**CITY OF
PARRAMATTA**

Heart of Play Master Plan

Phase 2 Engagement Outcomes Report

June 2021

Figure 4 - Priority actions for Doyle Ground (total responses n= 141)

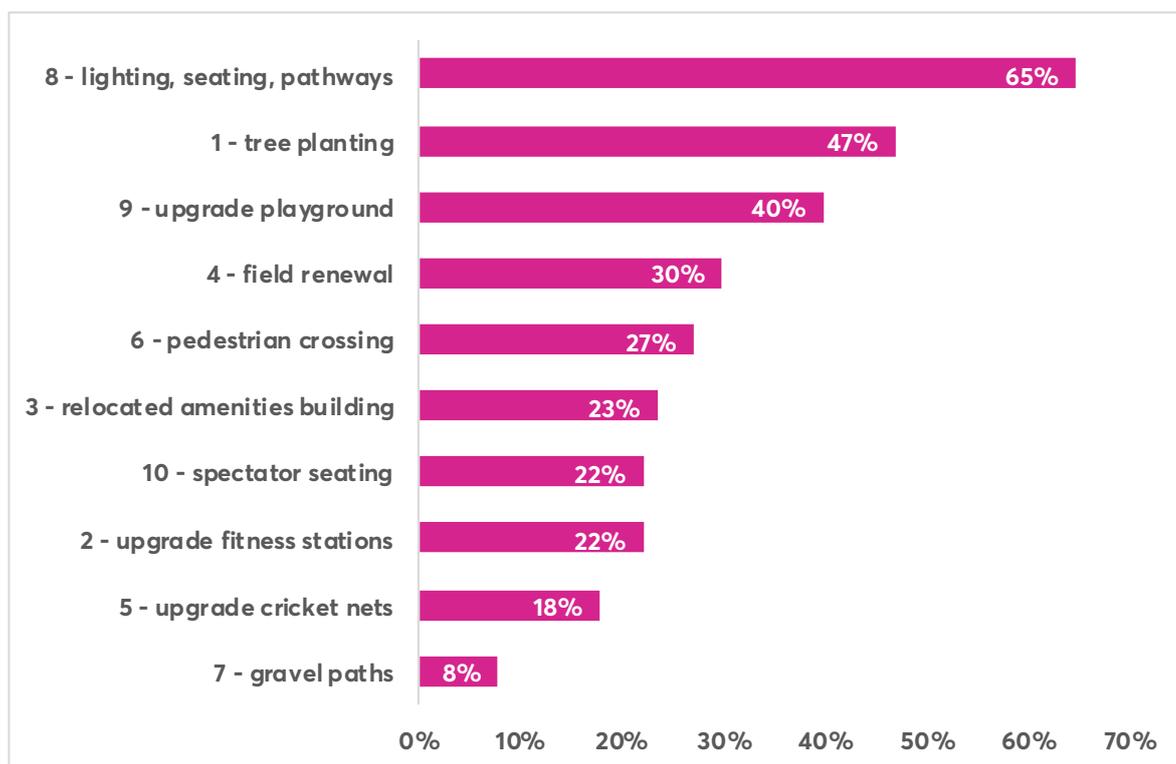
- Relocating the amenities building closer to the children's playground or additional toilets in close proximity to the playground (3 comments)
- Upgrading the amenities building (2 comments), with opportunities to include kitchen for community use.
- An additional amenities building in Doyle Ground (1 comment).
- Retaining the existing amenities building in its current location and upgrading the canteen, storage, toilets and change room facilities (1 comment).
- Toilets to be opened for longer hours in the day.
- One respondent would like to see a small, affordable community centre attached to the relocated amenities building for hire.

- Expanding the playground to accommodate the demand and high utilisation (4 comments).
- Increased amenities near the playground (3 comments), including additional tables, seating, shade and BBQ facilities.
- Play equipment for children of all ages (2 comments)
- Access to toilets within close proximity to the playground (2 comments)
- More types of play equipment (2 comments), such as swings and a flying fox.
- Improved maintenance of the playground (2 comments), particularly the fencing for safety of children near the road. (1 comment)
- One respondent would not like to see bark or gravel for surfacing of the playground.

- Safer pedestrian crossings (2 comments), particularly;
 - Towards Albert St East.
 - At the intersection at Macarthur and Isabella
- Opportunity for a bridge or a wide underpass as a crossing (1 comment).

Action 7 - Gravel paths to parking interface. 1m wide gravel paths to back of kerb, with low planting (max.1m high) buffer to street (2 comments)

"The current walking/running loop is great, and I wouldn't want it to be drastically changed. I am not in favor of replacing it with a gravel path (if that is what the change proposes)" - Survey respondent

Figure 5 - Priority actions for Barton (total responses n= 218)

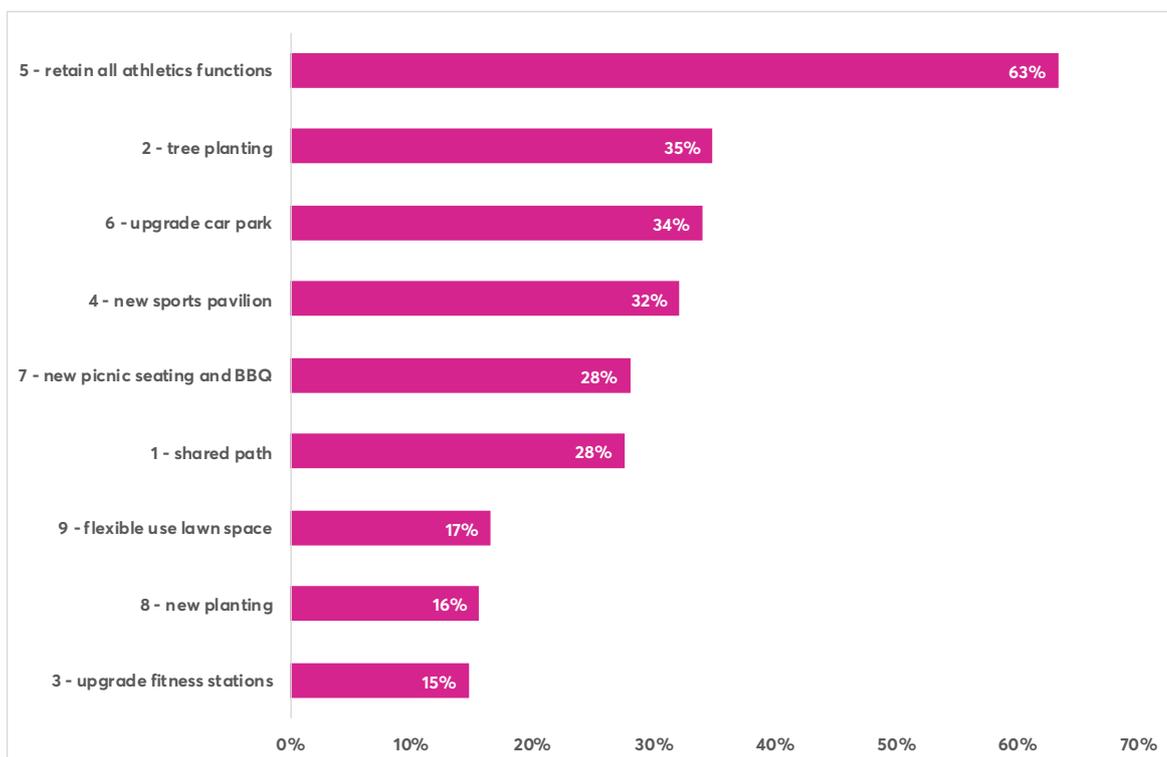
Survey respondents were asked if they had any additional comments on the actions proposed for Barton Park - 218 respondents answered this question. Overall, the majority of comments were unsupportive (151 comments) of Action 5 for Barton Park, expressing strong concerns and opposition for the proposed football field.

"I oppose this plan. My kids play soccer. However I don't want a soccer field at Barton park. There are so many other soccer fields around the area and we can keep easily going to them. All these years Barton park has been the ground for Parramatta Little As. My kids train, compete at zone on this very ground and enjoy doing athletics here. This ground is conveniently located for anyone to get through to." - Survey respondent

- One respondent would like to see deciduous trees, to balance sun and shade during the winter and summer months.
- One respondent expressed concerns for Action 2, indicating the area proposed for additional canopy tree planting is often used for athletics warm ups.

- Opportunity for different types of athletics tracks in Barton Park (4 comments), including:
 - A tartan running track (3 comments)
 - Synthetic/all weather athletics track (1 comment), and
- One respondent would like to see the existing grass track retained.
- Expressed concerns for asbestos on site in Barton Park (2 comments), with suggestion to raise soil levels.
- Expressed desire for basketball courts/ hoops (2 comments)
- Expressed desire for a pump track (2 comments), and a skate facility within the HOP network.
- One respondent would like to see a cafe for the public (1 comment)
- Opportunity for better use of existing field adjacent to PH Jeffrey (1 comment)
- Upgrade amenities, car parking and walking paths (1 comment)
- Expressed desire to expand existing playground (1 comment).

Figure 7 - Priority actions for Dan Mahoney Reserve (total responses n= 94)

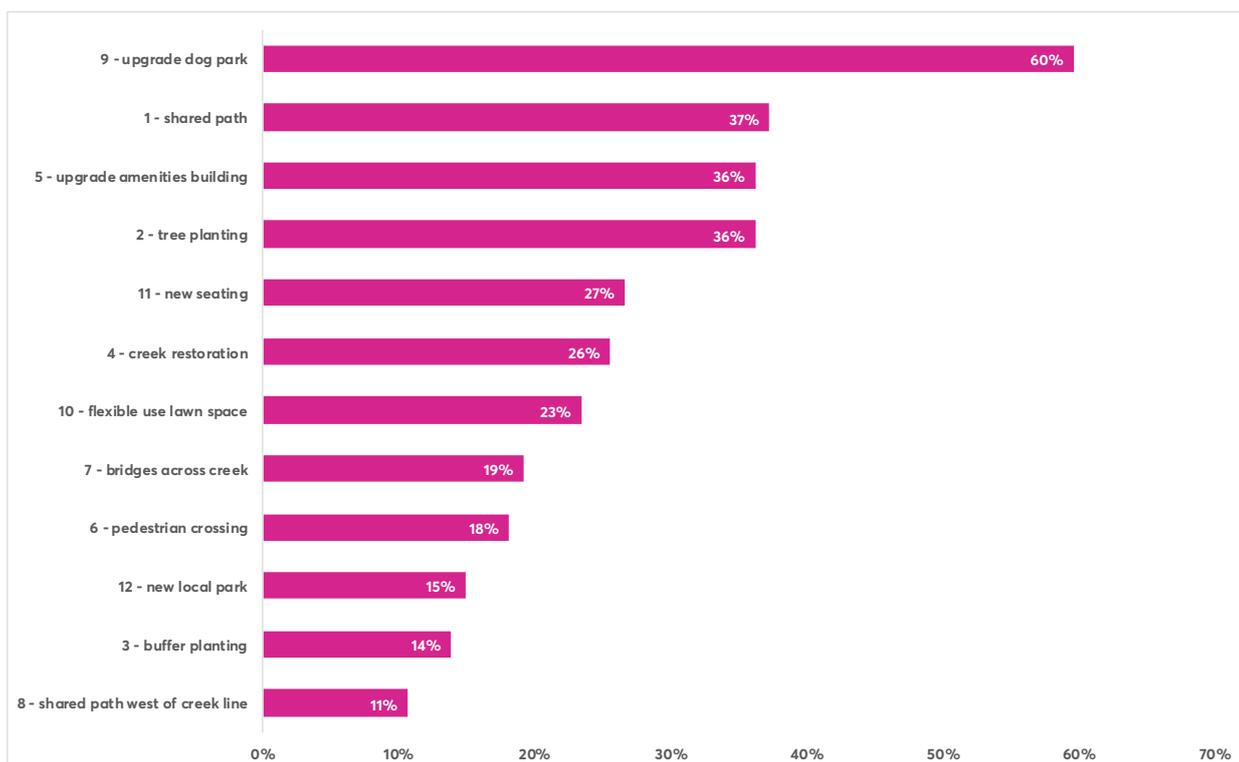
- Expressed desire for agility equipment (2 comments) particularly in the centre of the park.
 - Station for dog poo bags and bins (1 comment).
 - Double gates for safety of pets (1 comment)

- Installation of CCTV cameras (1 comment).
- Separated areas for small dogs and all sized dogs (7 comments), particularly:
 - Expressed need for separated areas for small dogs and large dogs, particularly to improve safety between dogs and minimise conflict between dog owners (3 comments)

"An extra area of half of Dan Mahoney won't provide more leisure area nor will be used properly given many other parks and playgrounds not being utilised most of the times. Therefore, this is big objection on dividing the park and put a so-called flexible use lawn space in Dan Mahoney. It's a unnecessary and useless proposal." - Survey respondent

"Natural tree canopy shade should be developed throughout the park, not just the perimeter. Perhaps this could be used down the middle of the park as a "natural divider " rather than physical fence between areas 9/10 as per proposed plan." - Survey respondent

- Providing tree canopy for shade throughout the park, not only on the perimeter (2 comments)
- Concerns proposed tree planting will not provide shade to the park or users.

"Where the proposed tree planting is will not provide shade to the park nor its users" - Survey respondent

Figure 8 - Priority actions for Old Saleyards and Corry Court (total responses n= 355)

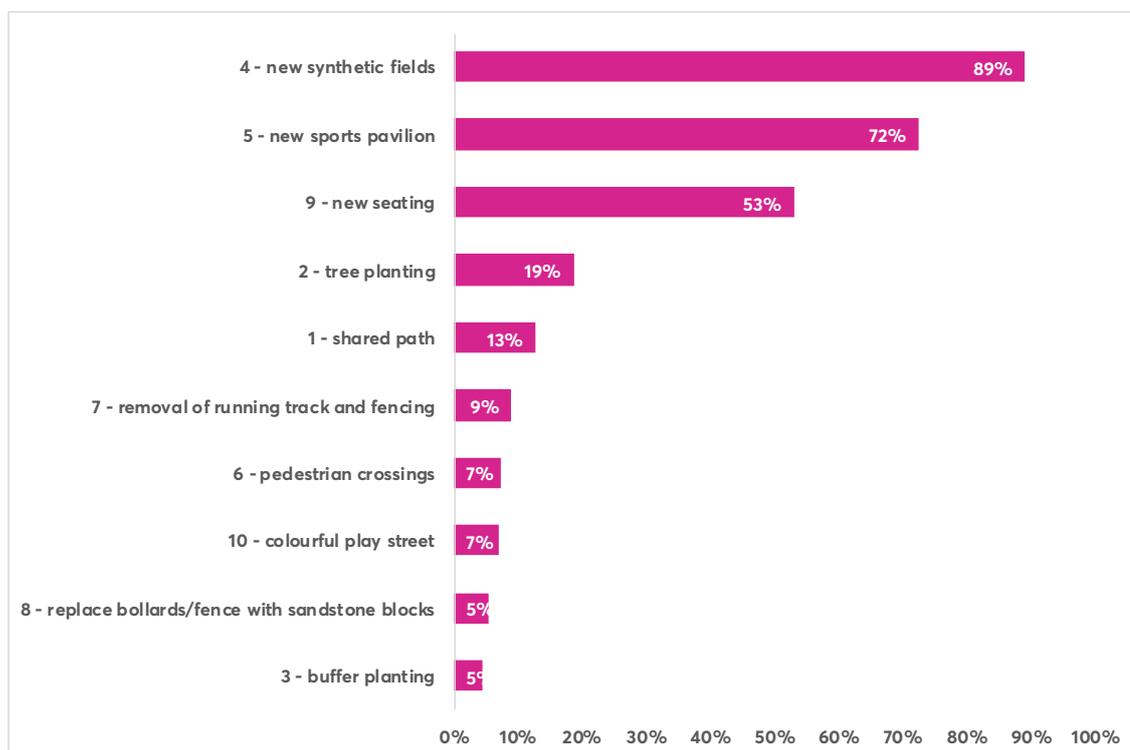
Survey respondents were asked if they had any additional comments on the actions proposed for Old Saleyards Reserve (OSY) and Corry Court - 219 respondents answered this question. Overall, the majority of comments focused on the need for synthetic turf that will accommodate hockey (196 comments).

"The synthetic fields will mean that the local junior rugby league team will have to leave. They have already been relocated due to changes at their previous field. How will you provide for them?" - Survey respondent

Figure 9 - Priority actions for Sherwin Park (total responses n= 62)

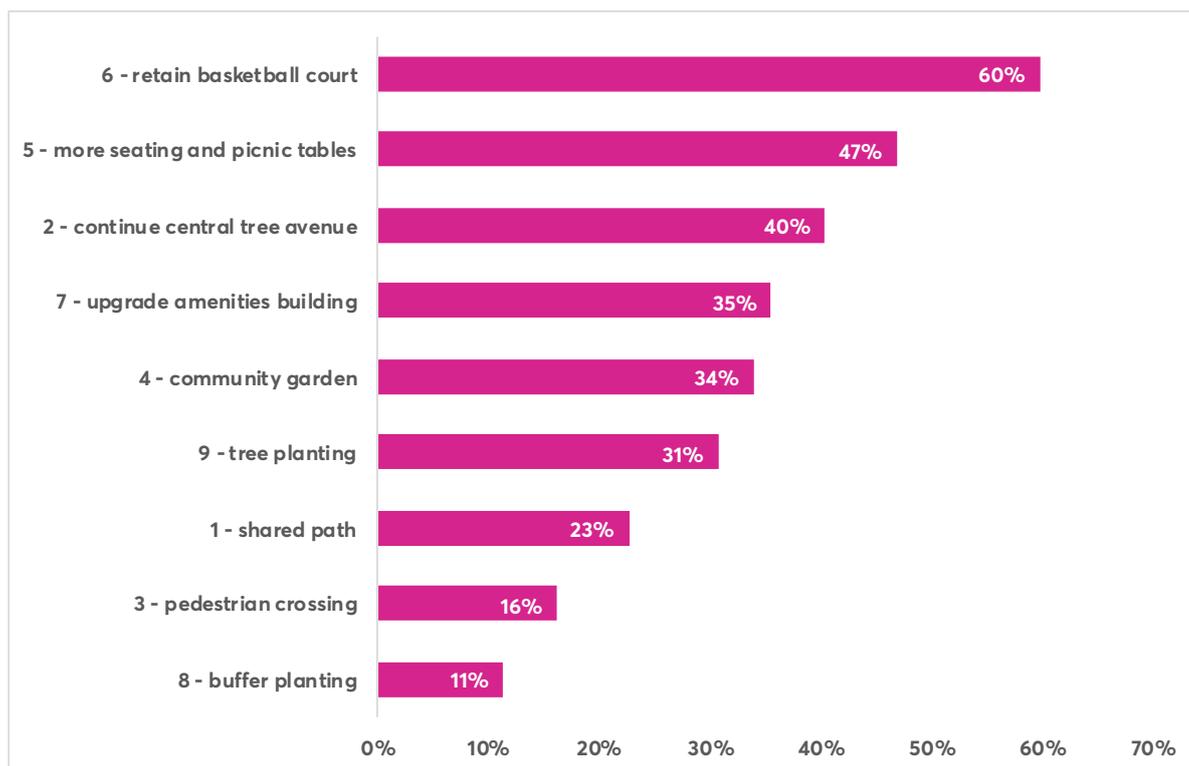
- Additional basketball courts in Sherwin Park (12 comments), including:
 - Full courts (3 comment)
 - A half or 1/3 courts with high hoops (3 comments)
 - Small court for children (2 comments)
 - Two respondents indicated the existing court is highly utilised by the same people, and would like to see additional courts to accommodate other users.
- Alternative surfacing of basketball courts (2 comments).
- Increased lighting at night to allow for play at the basketball courts (2 comment).
- Opportunity to fence the basketball court (1 comment).
- One respondent indicated they would like to see the existing court retained, particularly as it accommodates netball. This respondent would like to see an additional full or half court to be added in the higher section of the park.

"Instead of adding lowed hoops to the existing basketball court, please add a smaller one for kids. There are always some teens shooting hoops and it will become a problem if they have to share with the little ones. Keep them apart and keep everyone happy." - Survey respondents

"Please retain the netball ring and half/half netball/basketball style court. Could an additional court be added in the space on the high side of the park, or a half court with rings for additional practice?" - Survey respondents

"Pathway could be a cycle learning loop (i do not see one elsewhere in plan??)"- Survey respondent

- BBQ facilities (5 comments), particularly near the picnic tables
- Lighting at night (3 comments), particularly during the winter months and when daylight savings ends.
- Shade sails for increased shade (3 comments)
 - Over the playground, as it get hot in summer (2 comments)
 - For the morning sun.
- Increased toilet amenities including extended opening hours to access toilet and additional toilets (2 comment)
- Water bubbler facilities (1 comment)
- Fencing for safety of children (1 comment)
- Opportunity for a cafe (1 comment).

Figure 10 - Priority actions for PH Jeff Reserve (total responses n= 57)

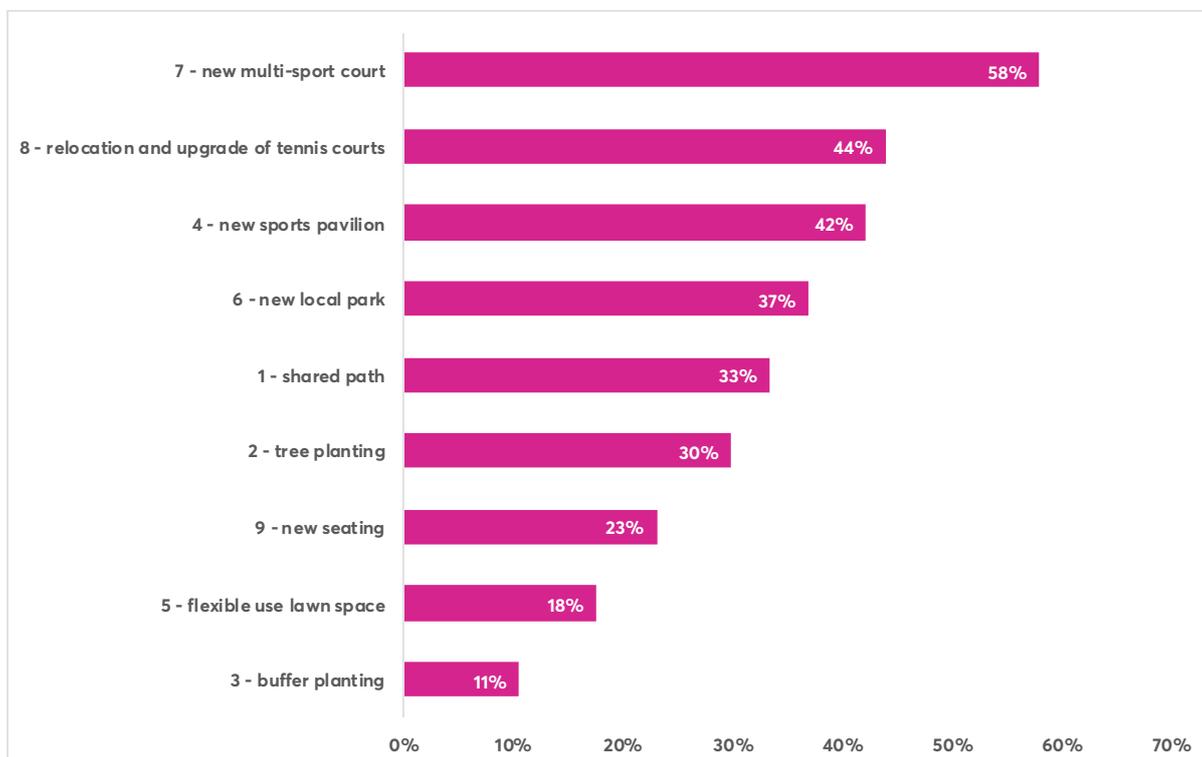
- Upgrade the tennis centre (1 comment)
- Retain existing tennis courts (2 comment). One respondent was concerned about any reduction in the number of tennis courts, stating that the courts that exist currently are always busy.
- Expressed desire for covered tennis courts (1 comment)
- One respondent is unsupportive of the relocation of tennis courts as they have been resurfaced recently.
- One respondent would like to know what is planned for the old tennis courts.

"Trees planted may disrupt the view from both areas." - Survey respondent

"Assuming the sector shaped sketch at action 5 is the existing discus cage, it is inaccurately positioned. Action 5 should say Athletics Field event throwing facility unless the intention is to remove the newly installed facilities there. It would be impossible to have seating along the perimeter of the soccer field closest to section 5 as discus would hit the seats and people on them endangering equipment and safety. I would like more information around safeguards that would prevent the PH Jeffrey soccer field and the #5 "Flexible space" being booked at the same time." - Survey respondent

- Increased basketball courts (5 comments)
 - One respondent would like to see basketball courts and fitness training equipment
- Increased badminton courts (1 comment)
- One respondent would like to see street hockey (roller blades) to be allowed at the proposed multi-sport court (1 comment)
- Opportunity to upgrade the existing soccer field at PH Jeffrey's to improve utilisation and accessibility (1 comment)
- Expressed desire for a playground in close proximity to the tennis courts (1 comment), especially to accommodate parents that can watch their children play tennis and other children to enjoy play.
- One respondent questioned if PH Jeffrey will accommodate a pump track.

"The use of PH Jeffrey is also part of the athletics club program, using the additional shot put and discus cages allows for more athletes to participate in events. If a path can be made from the gate on Barton Park to the discus cage this would help with taking heavy equipment between the two. Tress planted may disrupt the view from both areas." - Survey respondent
